EMS Apparels Ltd. (Extension)

31 October 2023

1. Building Information:

2. Observations:

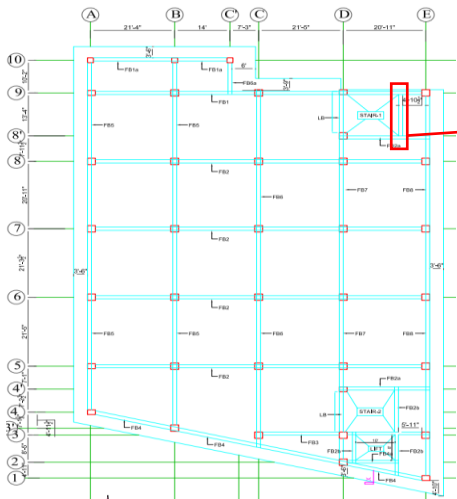
New Building	
Observation 1: Inconsistencies in design report.	
<ol style="list-style-type: none"> 1. As built architectural and structural drawings was available and we checked with the existing building and found ok. 2. Investigation has been done to find out rebar quantity and size of column, beam and slab. <li style="border: 2px solid red;">3. Concrete strength $f'_c=3500$ psi has been considered for Foundation, column and grade beam and 3000 psi for floor beam and slab as confirming by cylinder test report and contraction drawings. 4. Steel (rebar) strength 72500 psi has been considered for the analysis as per test report. 5. Live load= 60 psf minimum and 250 psf maximum in normal operation has been considered. 6. Wind load for Gazipur = 239 km/hr , seismic zone 2 (Z=0.2 & R=5) has been considered 7. A model based analysis by has been performed by ETABS 2017 8. Allowable soil bearing capacity = 3.26 ksf as per the soil test report 	<p>5.12.2 Frequency of Testing</p> <p>5.12.2.1 Samples for strength tests of each class of concrete placed each day shall be taken not less than once a day, nor less than once for each 60 m³ of concrete, nor less than once for each 250 m² surface area for slabs or walls.</p> <p>5.12.2.2 On a given project, if the total volume of concrete is such that frequency of testing required by Sec 5.12.2.1 above would provide less than three strength tests for a given class of concrete, tests shall be made from at least three randomly selected batches or from each batch if three or fewer batches are used.</p> <p>5.12.2.3 When the total quantity of a given class of concrete is less than 20 m³, strength tests are not required when evidence of satisfactory strength is submitted to and approved by the Engineer.</p> <p>5.12.2.4 A strength test shall be the average of the strengths of at least two 150 mm by 300 mm cylinders or at least three 100 mm by 200 mm cylinders made from the same sample of concrete and tested at 28 days or at test age designated for determination of f'_c.</p>

Material Specification in Design Report	Cylinder Test Criteria as per BNBC
<p>Description: A set of design reports was available for new building prepared following BNBC 2020. In the design report, the concrete strength has been considered of 3500 psi for the foundation, column, grade beam and 3000 psi for other members. However, during inspection insufficient concrete cylinder test report was found and that doesn't comply with the frequency of testing requirements as per BNBC (Part VI, Chapter 5, 5.12.2). So the building engineer is required to confirm the design strength of in situ concrete by taking 100 mm dia core (min 4 nos) from lower tier columns.</p>	
<p>SHALLOW FOUNDATION: The average bearing capacity of the shallow foundation as Isolated Column Footing: -To be considered 1.45 tsf (F.S. = 2.50) at a depth of 10'-0" measured from E.G.L. particularly at and around for BH - 01, 06. -To be considered 1.64 tsf (F.S. = 2.50) at a depth of 10'-0" measured from E.G.L. particularly at and around for BH - 02, 03, 04, 05. -To be considered 1.80 tsf (F.S. = 2.50) at a depth of 10'-0" measured from E.G.L. particularly at and around for BH - 07.</p>	<ol style="list-style-type: none"> 1. As built architectural and structural drawings was available and we checked with the existing building and found ok. 2. Investigation has been done to find out rebar quantity and size of column, beam and slab. <li style="border: 2px solid red;">3. Concrete strength $f'_c=3500$ psi has been considered for Foundation, column and grade beam and 3000 psi for floor beam and slab as confirming by cylinder test report and contraction drawings. 4. Steel (rebar) strength 72500 psi has been considered for the analysis as per test report. 5. Live load= 60 psf minimum and 250 psf maximum in normal operation has been considered. 6. Wind load for Gazipur = 239 km/hr , seismic zone 2 (Z=0.2 & R=5) has been considered 7. A model based analysis by has been performed by ETABS 2017 <li style="border: 2px solid red;">8. Allowable soil bearing capacity = 3.26 ksf as per the soil test report

Recommendation of soil test report	Allowable bearing capacity in design report
<p>Description: In soil test report, different bearing capacity is recommended for different bore hole. But in design report, average bearing capacity is considered for foundation check. FoS for some footing area found marginal considering adjacent bore log data. A geotechnical engineer is required to provide detailed calculations considering adjacent bore hole data in the design report and submit to RSC for review.</p>	
Observation 2: Inconsistencies in as-built drawings.
